**Protest of the Northern Corridor Final Environmental Impact  
Statement and Proposed Resource Management Plan Amendments  
Submitted to the BLM and USFWS  
by the Red Cliffs Conservation Coalition**

**NEPA Project Number:** DOI-BLM-UT-C000-2020-0001-RMP-EIS

**Submission date:** December 14, 2020

**Map 3.5-1. Wildfires, Kernel Density Tortoise Abundance, and Northern Corridor Alignments**

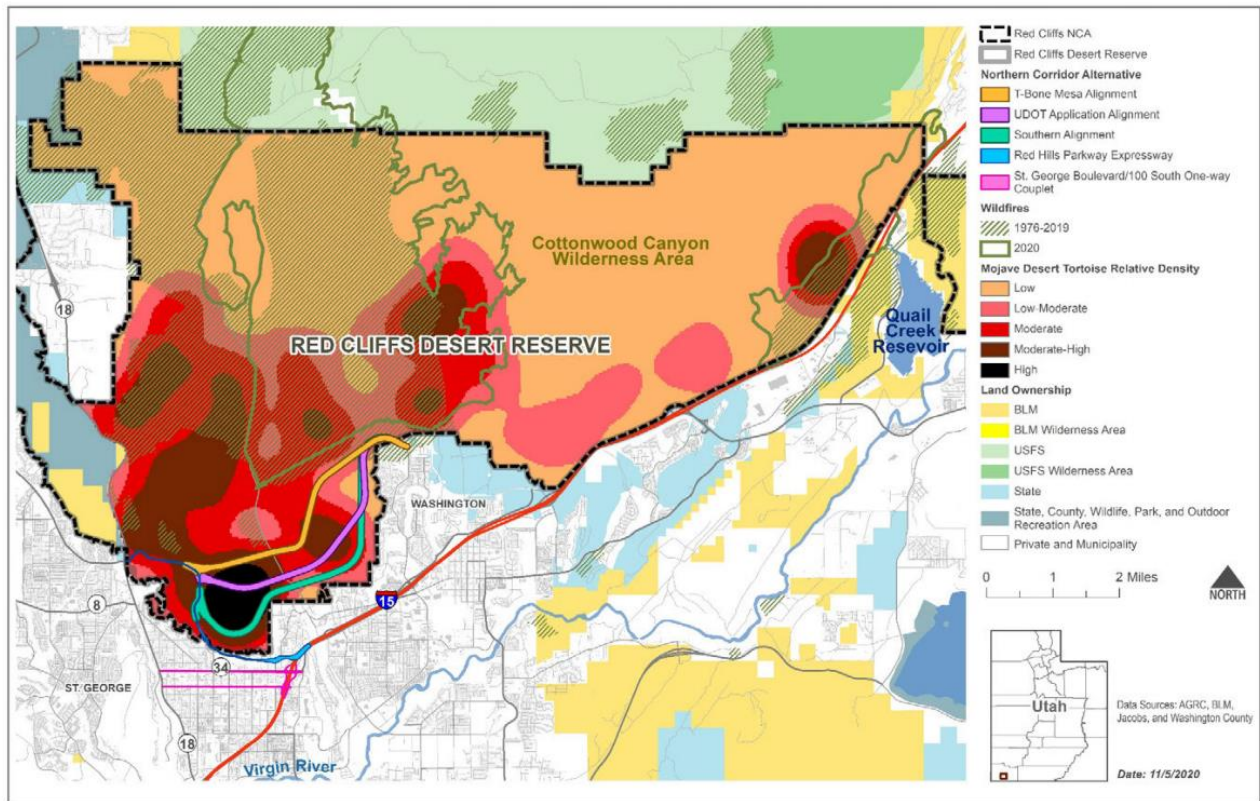
Map 3.5-1 from FEIS shows that the location of the Turkey Farm Road fire and the proposed UDOT's application alignment effectively separate the western portion of Zone 3 from the eastern portion. This makes it very difficult for adult tortoises with large home ranges to move across Zone 3 and impossible for smaller tortoises. The fire and highway together can be seen as pseudo-barriers, at least until native perennial and annual plant species are re-established.

accomplished. Therefore, BLM must provide a supplemental EIS with an accurate baseline Mojave desert tortoise population, considering the effects of the 2020 fire season.
